Access Compliance Report Public Rights-of-Way (Curb Ramps)

Main Street: **CHRISTY_LN** Cross Street: **ST_ALBANS_DR** Location: **SW**

ADA ID: **RPRK211221121023** Ramp Type: **Type 1 - Perpendicular Diagonal Initial Pass/Fail: Pass** Overall Compliance: **No** Severity Score: **12**

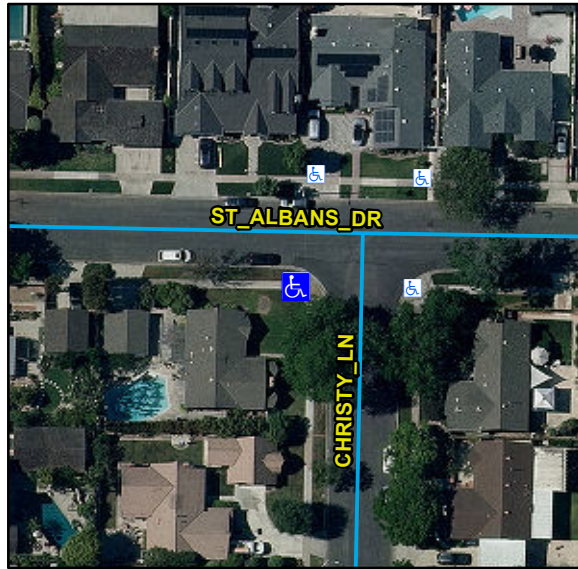
Compliance	Description	Data	Compliance	Description	Data
N/A	Ramp Length (in)	81	N/A	Flare Type LT	
Yes	Ramp Width (in)	48			Sloped
Yes	Ramp Run Slope (%)	8.3	N/A	Flare Slope LT (%)	4.5
Yes	Ramp Cross Slope (%)	1	N/A	Flare Traversable LT	No
N/A	Landing Present	Yes	N/A	Flare Type RT	
N/A	Landing Length (in)	48			Sloped
Yes	Landing Width (in)	48	N/A	Flare Slope RT (%)	6.9
No	Landing Run Slope (%)	2.8	N/A	Flare Traversable RT	No
Yes	Landing Cross Slope (%)	0.9	No	DWS Provided	No
N/A	Landing Movement Obstructed?	No	N/A	DWS Contrast	N/A
	Landing Movement Type	N/A	N/A	DWS Length (in)	N/A
N/A	Landing Shared	No	N/A	DWS Full Width	N/A
N/A	Clear Space	Yes	N/A	DWS Offset Left (in)	N/A
N/A	Clear Space To Crosswalk (in)	48	N/A	DWS Offset Right (in)	N/A
N/A	Marked Crosswalk 1	No	N/A	Marked Crosswalk 2	No
	Crossing 1 Direction	E		Crossing 2 Direction	N
	Marked Crosswalk 1 Width (in)	N/A		Marked Crosswalk 2 Width (in)	N/A

N/A	Ramp Inside Crosswalk 1	N/A	Yes	Ramp Inside Crosswalk 2	N/A
	Crossing 1 Slope (%)	4.6		Crossing 2 Slope (%)	5.7
	Crossing 1 Cross Slope (%)	0.5		Crossing 2 Cross Slope (%)	0.8
Yes	Gutter Ponding	No	Yes	Curb Slope	2.9
Yes	Gutter Lip Height (in)	0		Road Run Slope (%)	0.7
Yes	Gutter Run Slope (%)	3.9		Road Cross Slope (%)	6.9
Yes	Gutter Cross Slope (%)	1.7			
Yes	Overall Surface Condition: Acceptable		No	Perp Joint Present	No
	Cross Gutter Present?	No		Spandrel Present?	No
	Replace Cross Gutter?	N/A		Replace Spandrel?	N/A

Remove & Replace Curb Ramp With Two New Directional Ramps or Equivalent.
